Deadline 6 Submission on Behalf of the Neighbours and Users of Queen Elizabeth Park

Nick Jarman

Interested Party reference no: **20022545**

Rough diagram of Farnborough Hill sports facilities, drawn by a current pupil

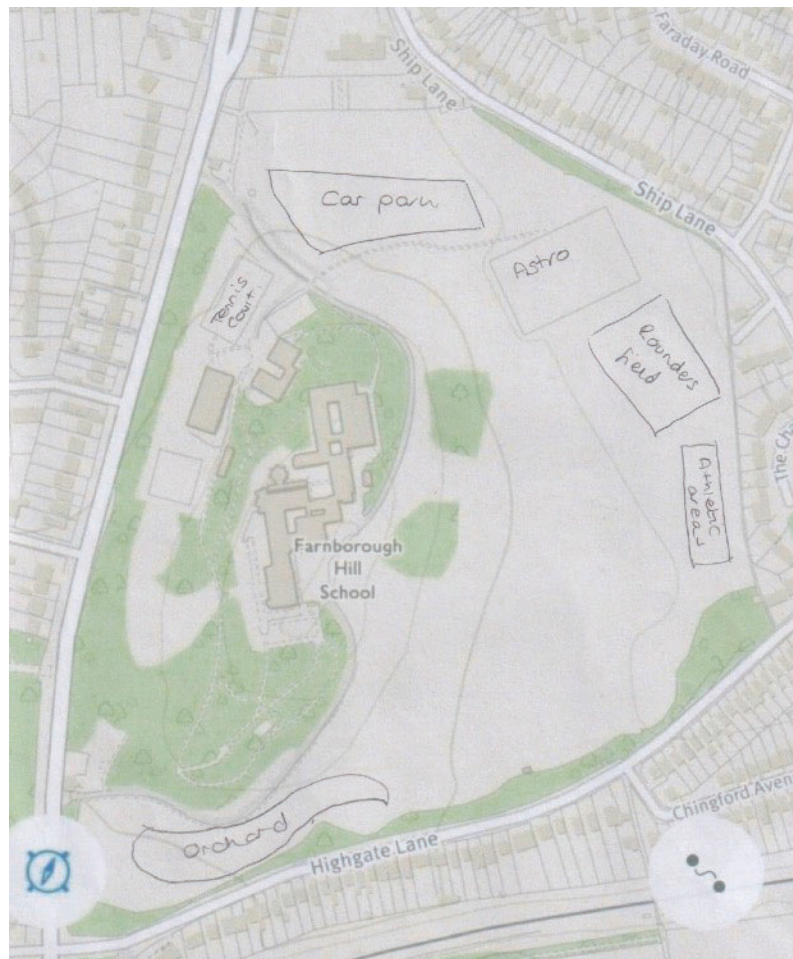
Outdoor sports facilities at Farnborough Hill are in the northern and eastern areas of the grounds, as shown on the map below. The annotations were drawn by a current pupil at the school.

Assuming a shortened HDD bore where the stringing area can be completely accommodated in the school grounds, the pipe string might intersect with the athletics area, however the same is true of narrow working area NW18, which runs through the same space.

Scale: 1:500 @ A3
Drawing No: 182825006
Drawing Name: QEP Additions

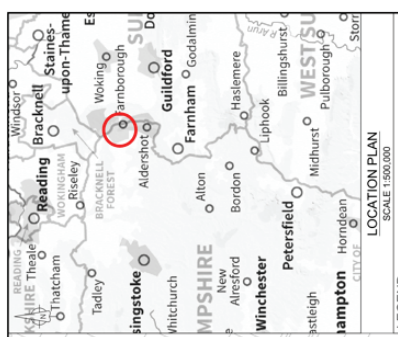
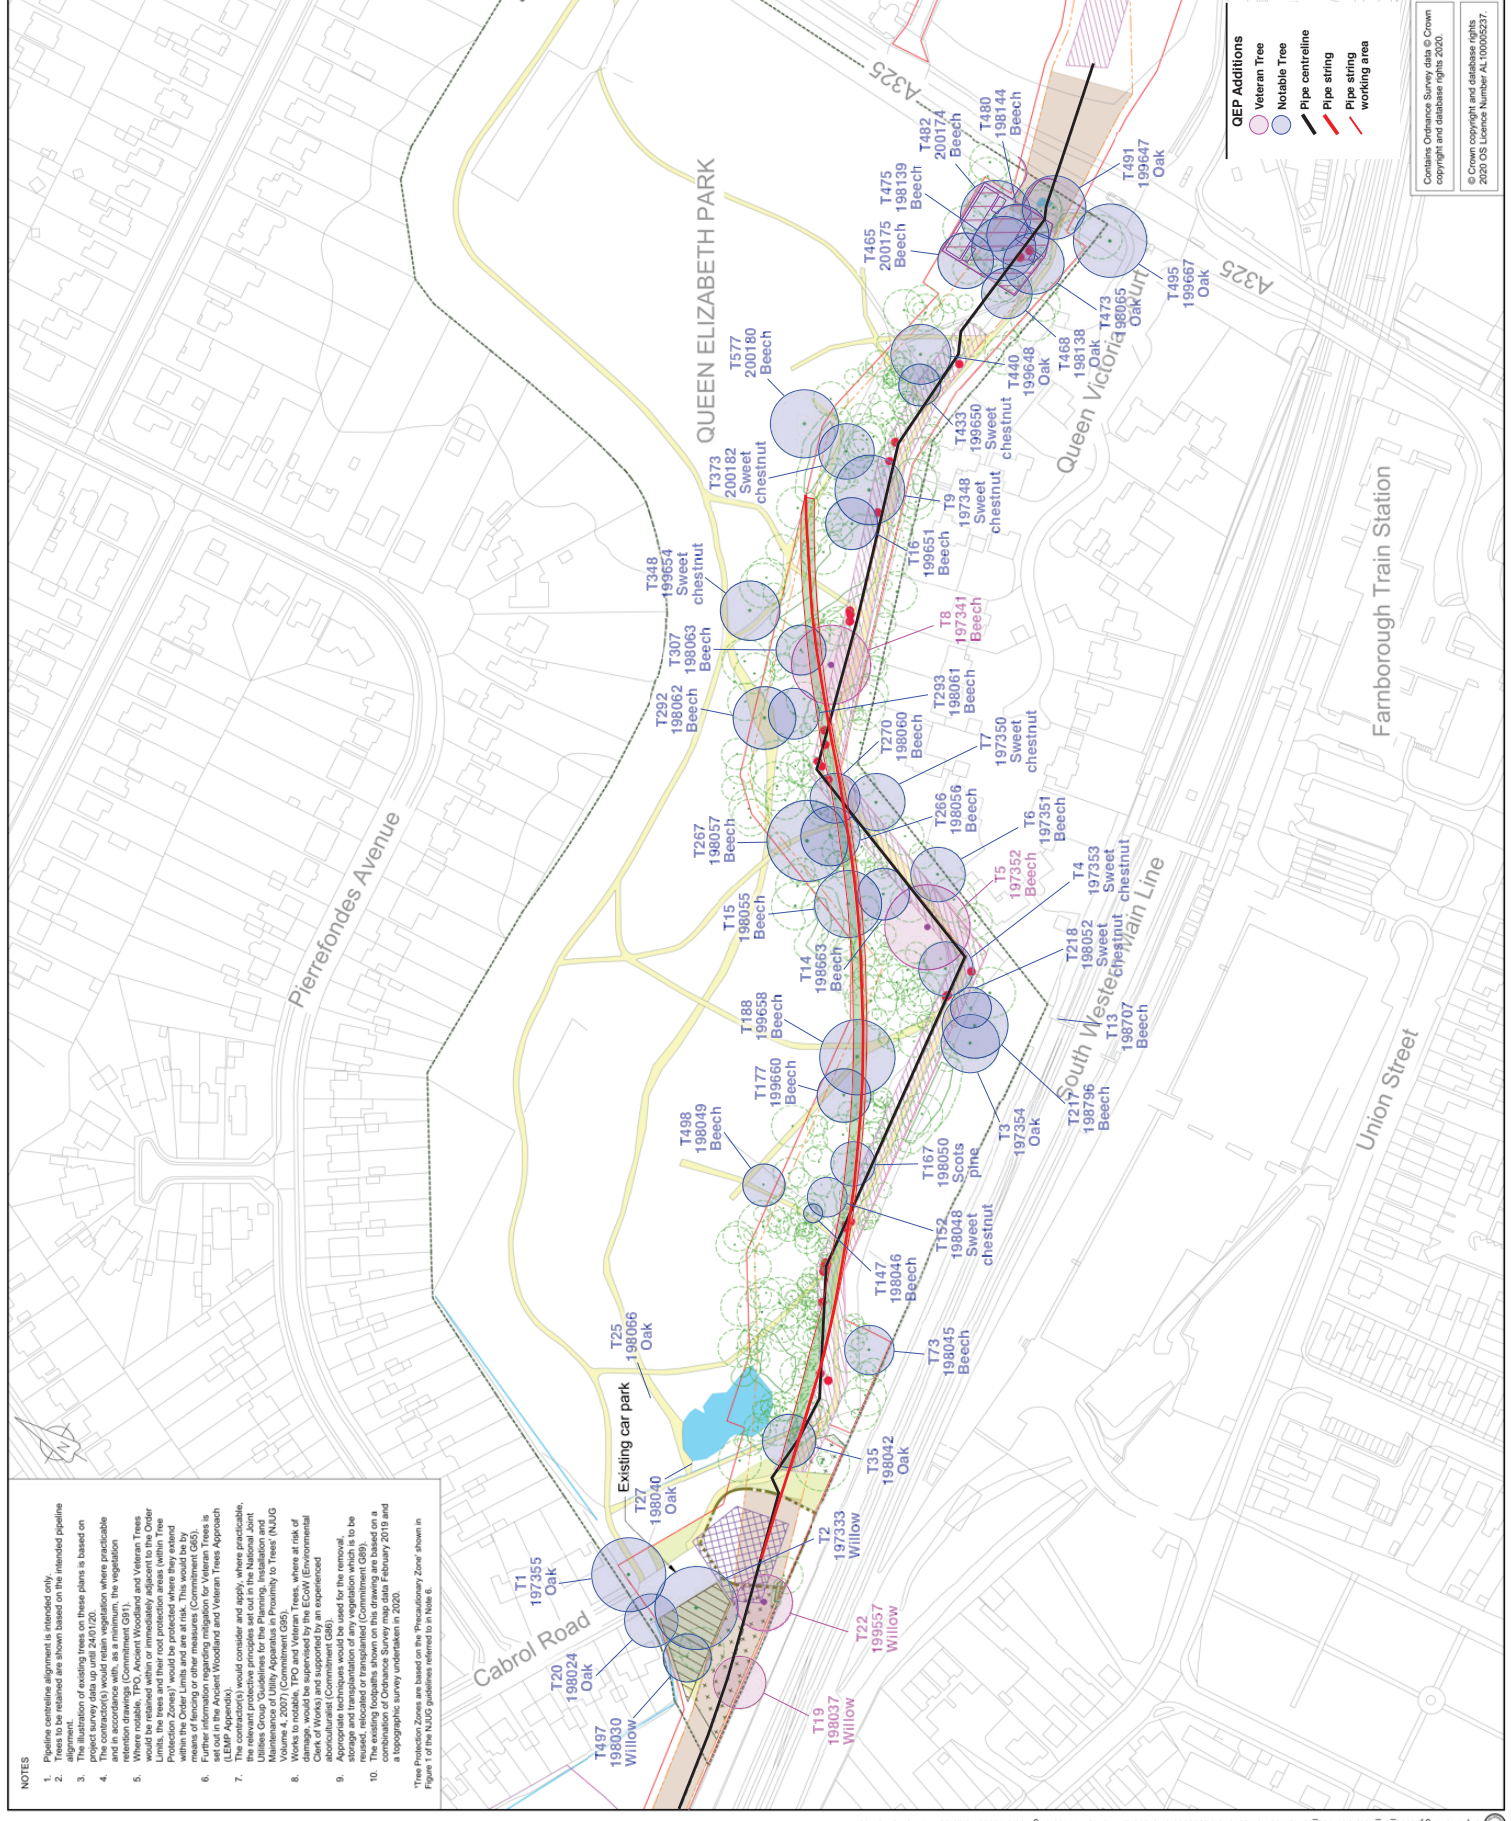
Two of the Notable Trees are within the auger bore compound, these are identified on Esso's tree survey as S2700-T465-C2 and S2700-T482-C2. Both are beech and the ATI numbers are 200175 and 200174 respectively. With the addition of these trees, 99% of the auger bore compound's area is covered by Notable Tree RPAs and they block the whole width of the Order Limits at this point.

The other two Notable Trees are a sweet chestnut (S2700-T373-B2) and a beech (S2700-T577-B2). ATI numbers are 200182 and 200180. In conjunction with Notable Tree 197348 (T9) these now effectively block the width of the Order Limits.

Updated versions of the affected drawings submitted at Deadline 5 are included below.
